10.2 Turbine Generator

The information in this section of the reference ABWR DCD, including all subsections, tables and figures, is incorporated by reference with the following departures and supplements.

Figure 10.2-1 Turbine Stop Valve Closure Characteristic

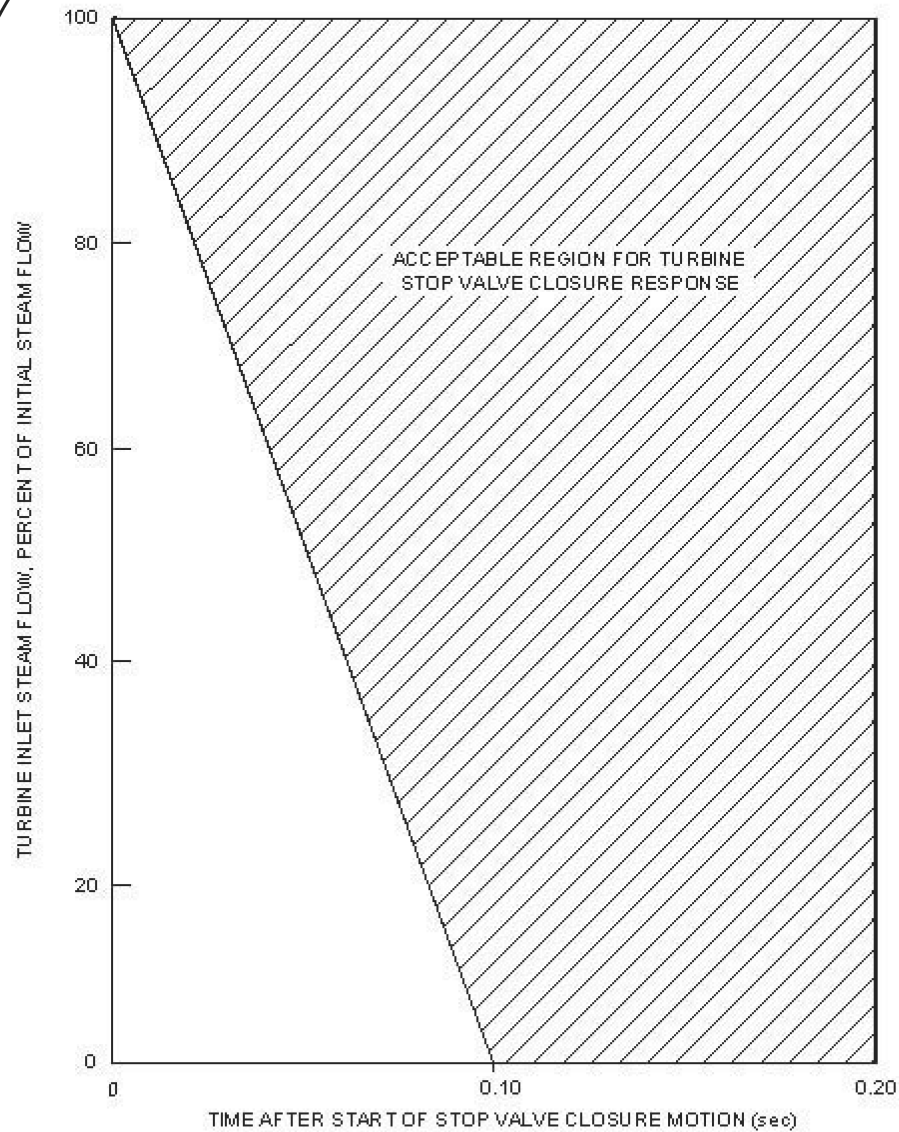
STD DEP Admin (Figure 10.2-1)

Figure 10.2-4 Generator Hydrogen and CO₂ System

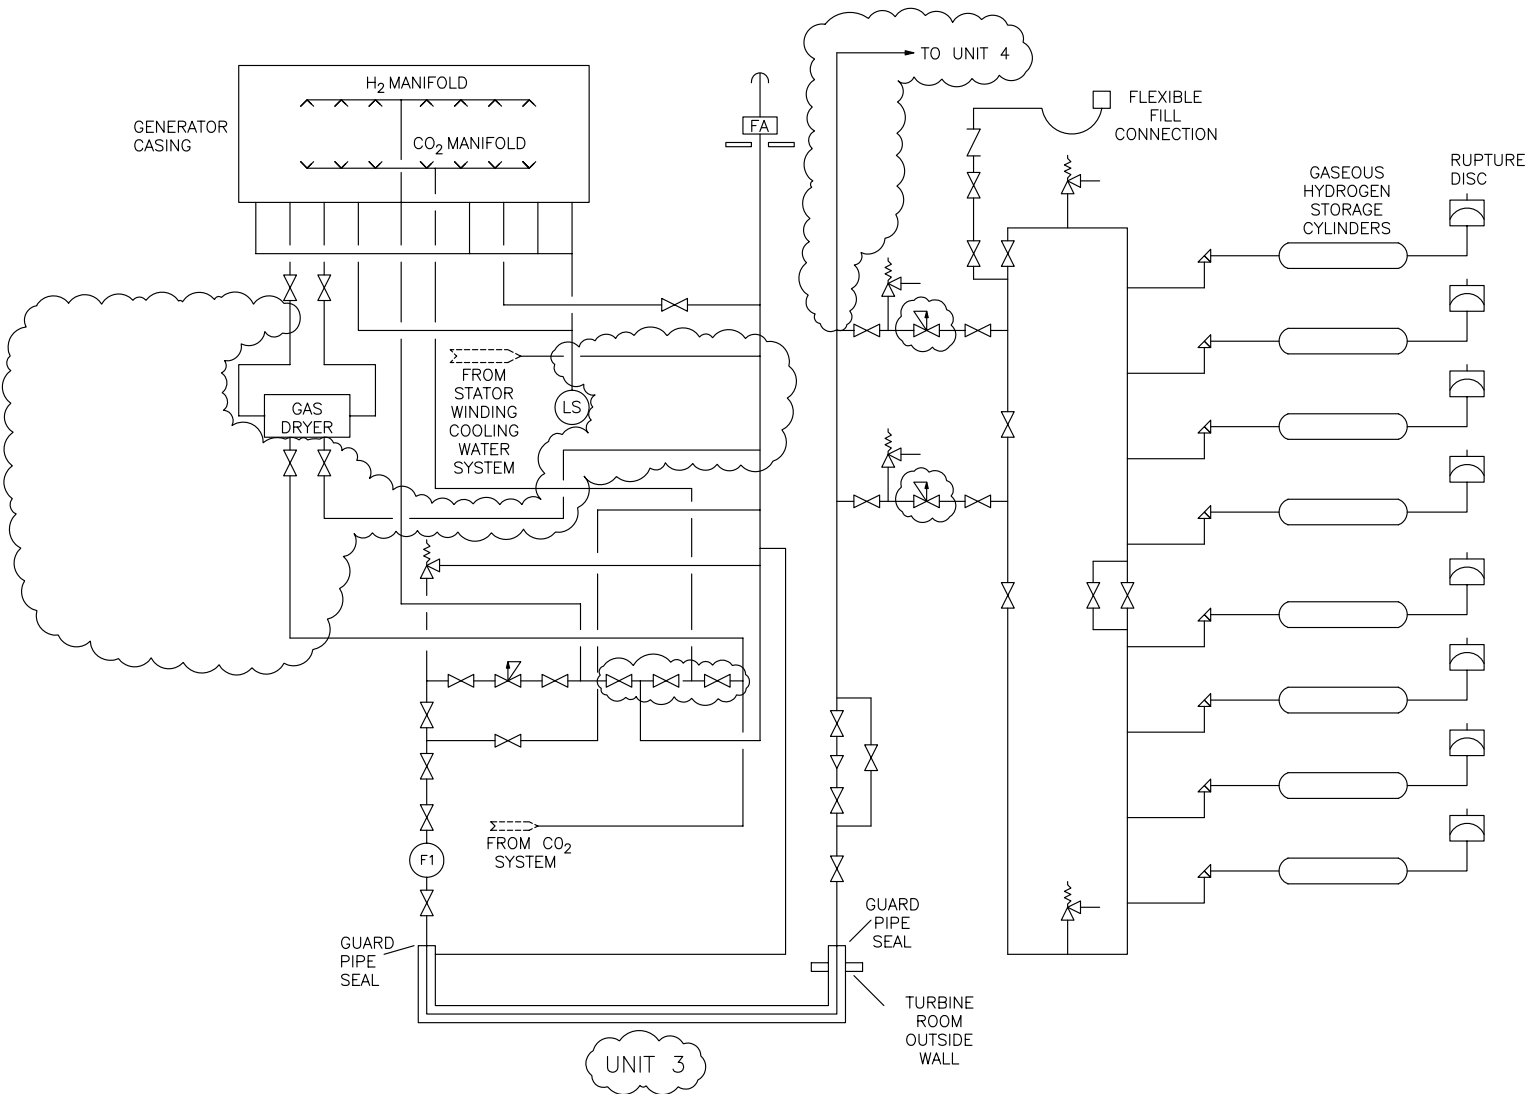
STP DEP 1.1-2 (Figure 10.2-4)

STP DEP 10.2-1 (Figure 10.2-4)

Bulk Hydrogen System—*The bulk hydrogen and CO₂ system is illustrated on Figure 10.2-4. The hydrogen system is designed to provide the necessary flow and pressure at the main generator for purging carbon dioxide during startup and supply makeup hydrogen for generator leakage during normal operation.*

storage facility will be used to store hydrogen compressed gas cylinders for STP 3 & 4. The bulk hydrogen storage is located outside ~~but near~~ the Turbine Building and at least 100m from any safety-related building. The hydrogen lines are provided with a pressure reducing station that limits the maximum flow to less than 100 standard cubic meters per minute before entering the Turbine Building. Equipment and controls used to mitigate the consequences of a hydrogen fire/explosion will be designed to be accessible and remain functional during the postulated postaccident condition. The design features and/or administrative controls shall be provided to ensure that the hydrogen supply is isolated when normal building ventilation is lost.

Figure 10.2-5 Turbine Overspeed Trip System Functional Diagram

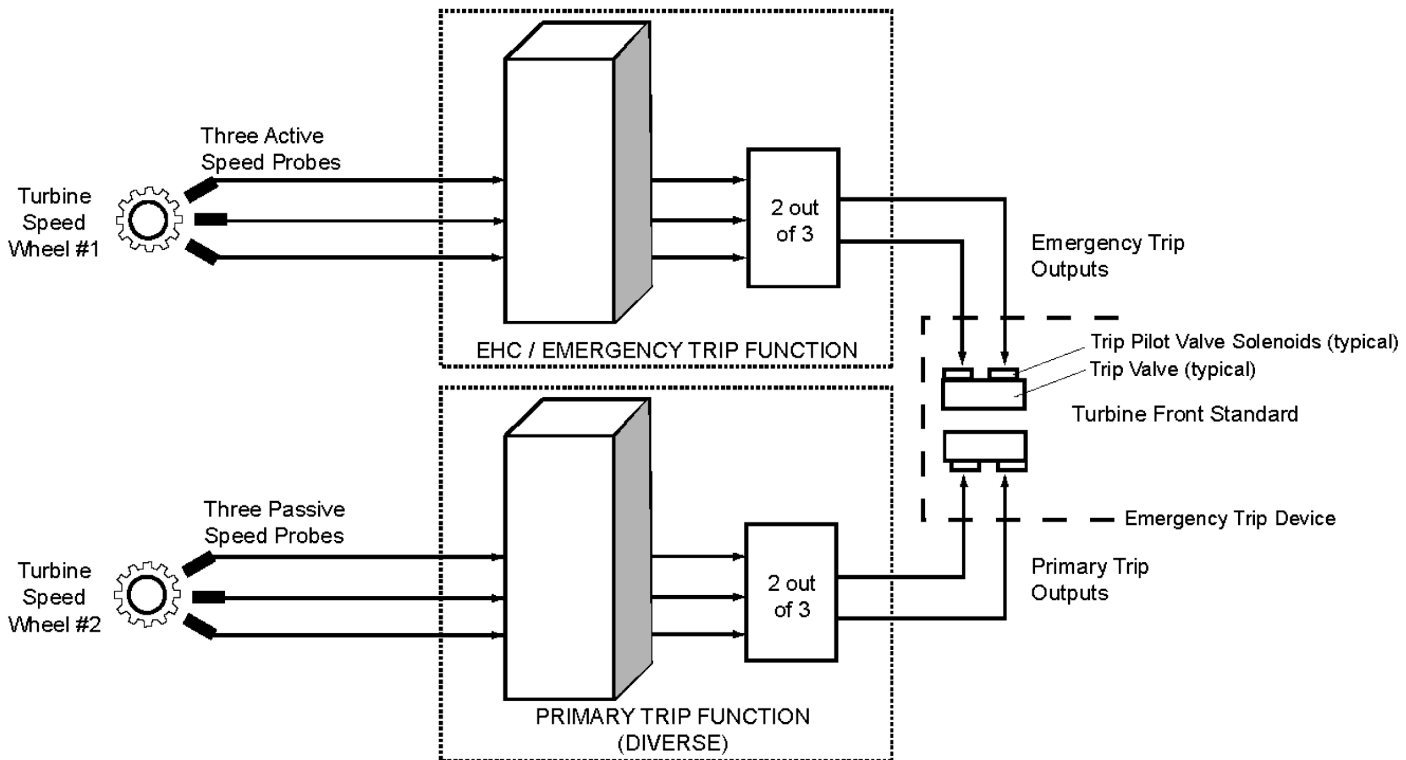
The primary trip function is independent and diverse from the emergency trip function as explained below (refer to Figure 10.2-5, Turbine Overspeed Trip System Functional Diagram). Two-out-of-three logic is employed in both the primary and emergency overspeed trip circuitry. Each trip function can de-energize its associated trip pilot valve solenoids of the electro-hydraulic Emergency Trip Device (ETD). The ETD is composed of two independent trip valves, each with two normally energized fail-safe solenoids. For each trip valve, each trip pilot valve solenoid is powered from a separate power source. The solenoids de-energize in response to detection of an overspeed condition by the turbine speed control logic. De-energization of both trip pilot valve solenoids is necessary to cause the spool in their respective trip valve to reposition, which depressurizes the emergency trip fluid system, rapidly closing all steam inlet valves and indirectly closing the steam extraction nonreturn valves. Accordingly, the repositioning of only one of the two trip valves is necessary to trip the main turbine. A single electrical component failure does not compromise trip protection, and does not result in a turbine trip. Each trip valve in the ETD is testable while the turbine is in operation.

The diverse primary overspeed trip function utilizes three passive speed sensors that are separate from the active speed sensors used for normal speed control and emergency trip function. Speed sensors are diverse (passive and active sensors) between primary overspeed and emergency overspeed trip. Speed sensing for primary and emergency overspeed trip functions also use separate speed wheels (refer to Figure 10.2-5). Each speed signal for the primary trip function is compared to a speed

setpoint of approximately 110% of rated speed, and produces trip signals arranged in two-out-of-three logics, to de-energize both trip pilot valve solenoids of one of the two trip valves of the ETD. Both trip pilot valve solenoids must be de-energized to trip the associated trip valve. The ETD has two redundant trip valves. Tripping of either redundant trip valve will drain the emergency trip fluid, resulting in a turbine trip.
